**. CITY OF SACRAMENTO .**  
**. DESIGN REVIEW - PRESERVATION BOARD .**

**LOCATION:** 1806 Capitol Avenue

**PROPOSAL:** The applicant proposes conversion of a vacant former auto repair garage to a restaurant/deli.

PB 90-040

**Capitol Avenue Elevation**  
1/8"=1'-0"

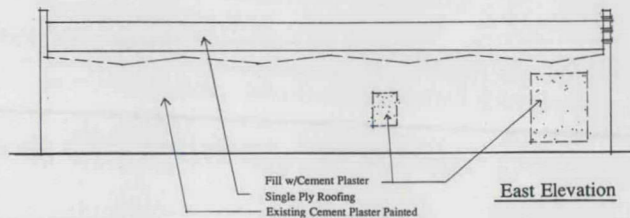
The roof open air courtyard that will be created behind the original facade will provide a transitional space for entry into the establishment(s). Leaving the original doorway and one of the two windows as openings to the courtyard and providing a new storefront behind it is not objectionable. Potentially, a very pleasant and attractive space can be achieved. Design Review/Preservation staff would not be surprised with some future use of the courtyard for additional seating. However, in contrast to the sidewalk seating provided next door, the courtyard space will be somewhat protected from the weather.

3. The design includes the elimination of two windows on the east side of the building. Staff suggests that the larger northerly window be retained. This is in keeping with preservation policy and will maintain more of the original design character of the building.
4. The site plan indicates planting in front of the building, both in the streetside planter area and on each side of the entrance opening. Staff is concerned that the planting that is initially installed might at some future time become trampled by customer seating taking over the public right-of-way. Bare ground in those areas would not be a visual asset for the property.
5. Signage is conceptually identified on the applicant's exterior perspective. The placement of building addressing is inconsistent between the perspective and the street elevation.

1. Elevation drawings of the interior of the courtyard, the new storefront, the water feature and the courtyard gate shall be submitted to staff for review and approval.
2. The larger of the two windows proposed to be removed from the east side of the building shall be retained.
3. Landscape and irrigation plans shall be submitted for review and approval of staff, with assistance from the Board's landscape architect member. Any subsequent modifications to the approved plans shall also be subject to review and approval.
4. The signage and the exterior lighting fixtures shall be subject to staff review and approval.
5. Final plans shall be submitted for review and approval prior to issuance of building permits.

Perspective Sketch

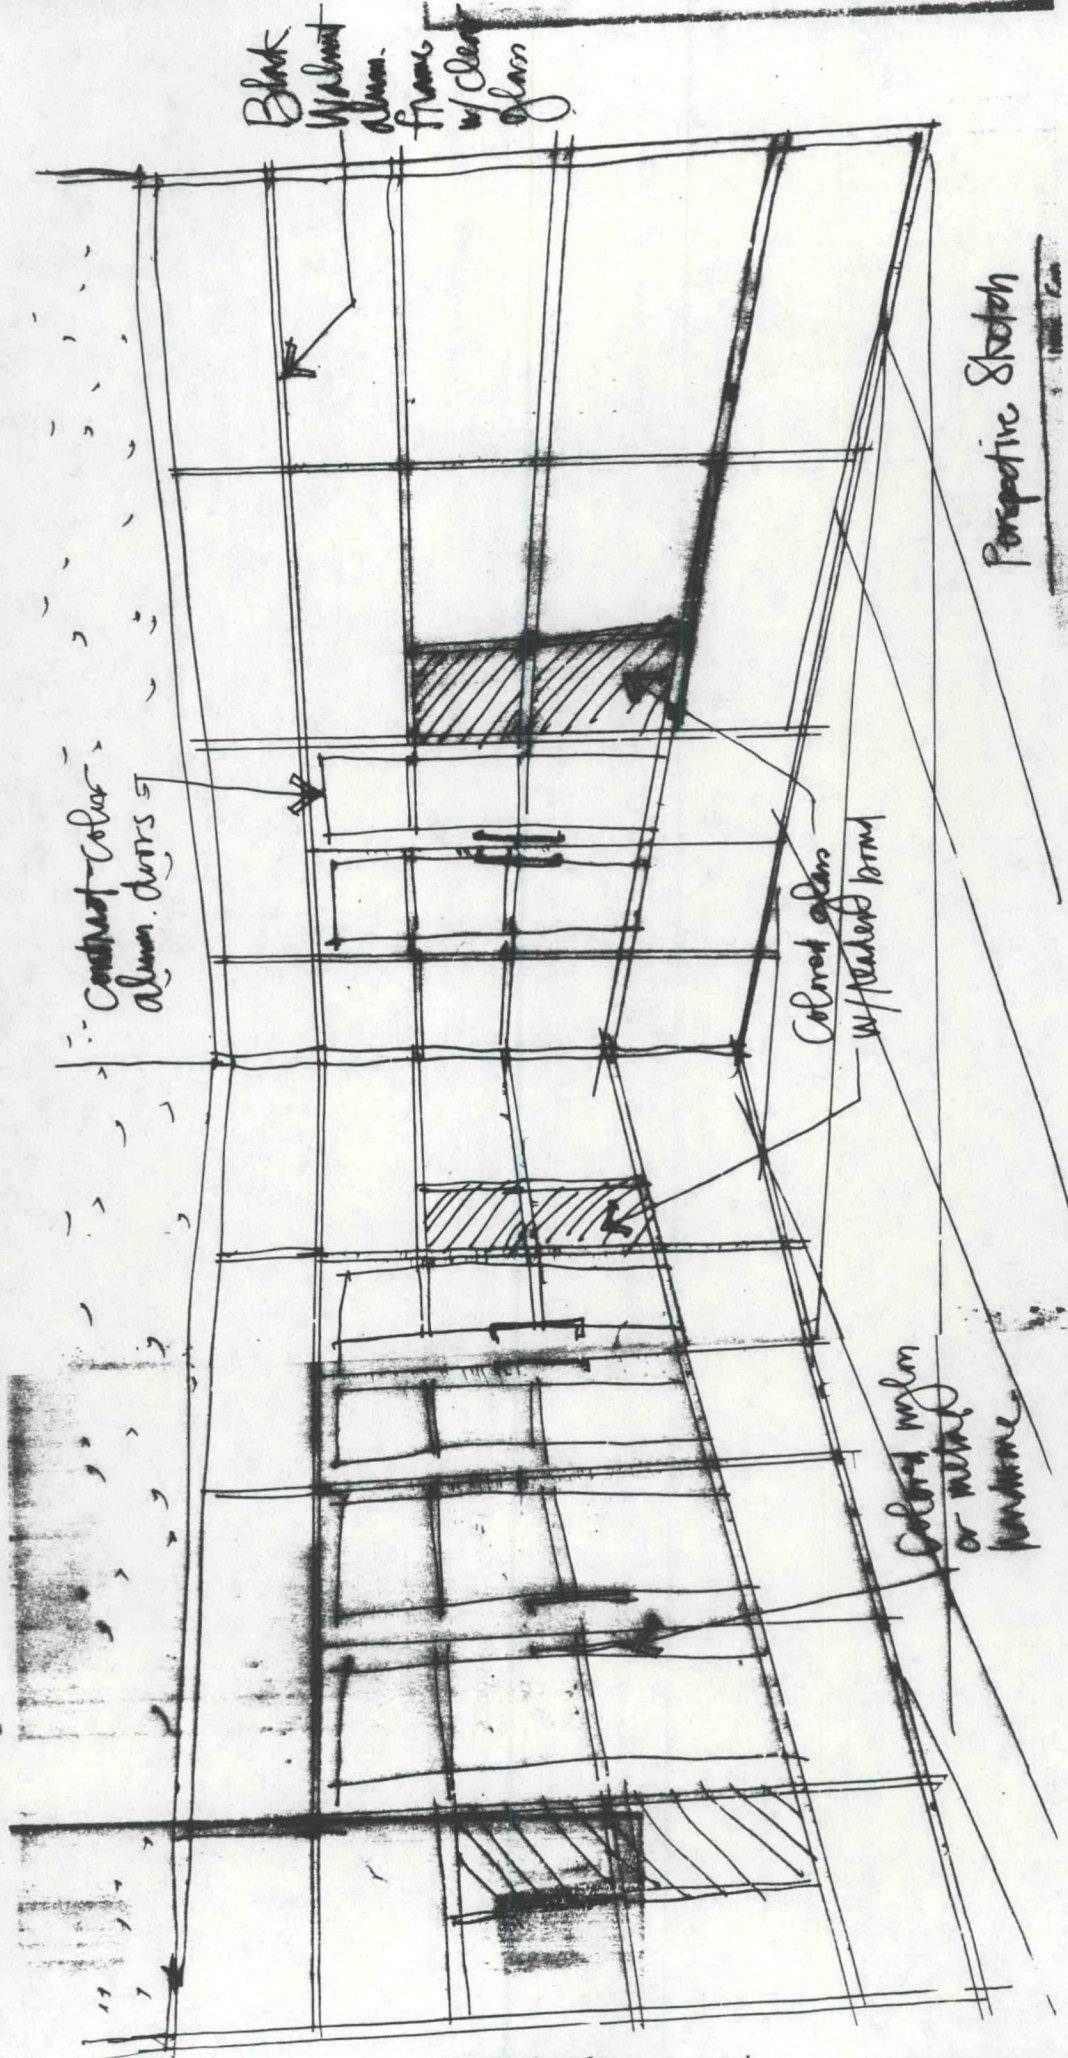
2. At the request of staff, the applicant provided a supplemental drawing---a sketch of the storefront. The modern glass and aluminum design of the storefront will be in dramatic contrast with the original brick facade of the former auto garage. Staff is supportive of this treatment, in that the contrast also serves to highlight the original facade and its detailing. However, subsequent review of the more detailed final drawings of the storefront and also perhaps that of the water feature should be required.
